QUALITY ASSURANCE -- NON-CONFORMANCE REPORT

Report No: NCR-000383

Reference Description: Adjustment to Segment 1AAW/1AW stiffeners offset exceeding the allowable DCP tolerances

Job Name: SAS Superstructure

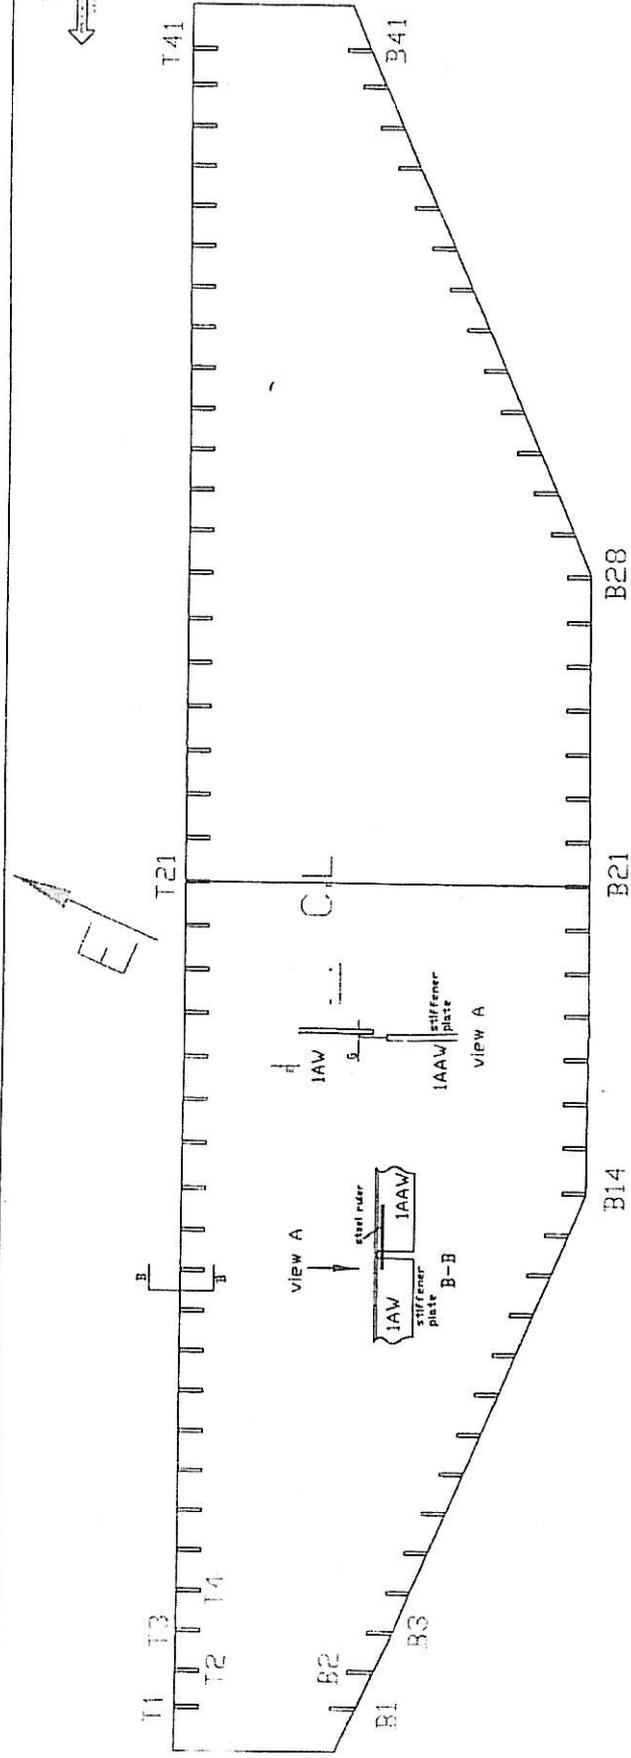
Per discussion with Caltrans/TY Lin at Shanghai, ABF proposes to use the lateral bracing details shown below at Segment 1AA to Segment 1A stiffener connections to address any concerns about eccentric loading due to relatively large slope. The locations of the stiffeners requiring this lateral bracing are highlighted in the attached spreadsheet. Also attached are stiffeners offset surveys performed by ABF prior to any adjustment made. Please note the proposed lateral bracing will only be used for deck plate stiffeners. The offset of bottom or side plate stiffeners have been corrected by adjusting stiffeners at both Segment 1AA and 1A ends.

1. All measurements are between CL of 1AAW stiffener and 1AW stiffener.
2. Max cutback length of 1AA stiffener to skin plate weld is approximately 600mm, which can have 4mm adjustment per 1:150 slope.
3. T14 is designed as flush at the Counterweight side, thus the theoretical CL offset should be -5mm.
4. T28 is designed as flush at the Bikepath side, thus the theoretical CL offset should be 5mm.

The proposed lateral bracing details to address concerns about eccentric loading is acceptable. The details can only be used at deck plate stiffeners (end stiffeners) at the following locations (survey points):
 Stiffener connections at segments 1AAW and 1AW: T2, T3, T15, T16, T17, T29, T30, and T32
 Stiffener connections at segments 1AAE and 1AE: T2, T29

The material for brace plates shall meet the requirement for end stiffener plates.

Stiffener plate alignment survey

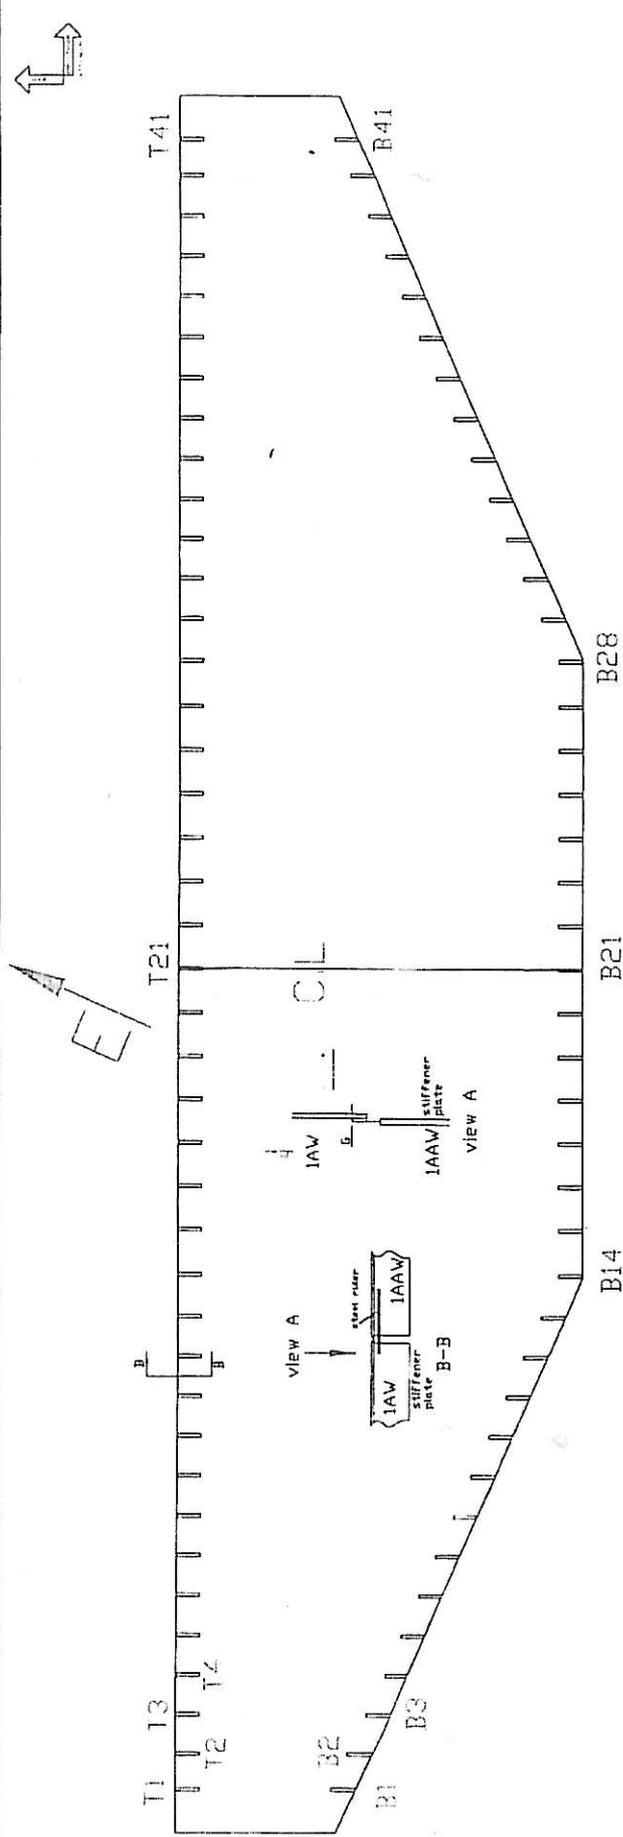
Caltrans Quality Assurance (QA) Inspector observed the joint survey on stiffeners offset measurement at OBG Segment 1AAW to 1AW. In comparing the offset survey data on July 29, 2009 provided by ABF to the joint survey data on August 11, 2009, it was found that the stiffeners with offset exceeding 3mm tolerance previously have now been corrected. Per the "approved as noted" Dimensional Control Plan (DCP) revision 8, it was found that a correction of each millimeter offset should require a stiffener unzip length of 150mm. According to the QA measurement of the total unzip length at 18 locations on the Segment 1AAW end stiffener and 1AW open rib stiffener, the adjustment made to these stiffeners have exceeded this DCP requirement of L/150. Following the notation used on the previous survey data, these 18 locations are labeled as T2, T3, T4, T5, T6, T15, T16, T17, T20, T28, T29, T30, T31, T32, T33, B5, B7, and B13.

Based on a joint QA survey by CT and ABFJV, there are stiffeners not listed in ABF-RFI-001870R00 being found exceeding the 1:150 slope at 1AAW to 1AW splice. They are: T4, T5, T6, T20, T28, T31, T33, B5, B7, and B13, see NCR ZPMC-0357. ABFJV proposes to use the approved lateral bracing details to correct those stiffeners, as well as any additional stiffeners exceeding the 1:150 slope at 1AAE to 1AE splice identified by future QA survey.

The Contractor's proposal to correct the above referenced stiffeners using the previously approved (RFI 1870R0) lateral bracing details, is acceptable with the following additional requirements:

In the RFI-1870R0 bracing detail, the second PL 24x230 brace is illustrated to be 600mm away from the centerline of the segment. However, if the bend line is located at another distance away from the splice, the second PL24x230 shall be located at no more than 50mm from the bend lines on either side.
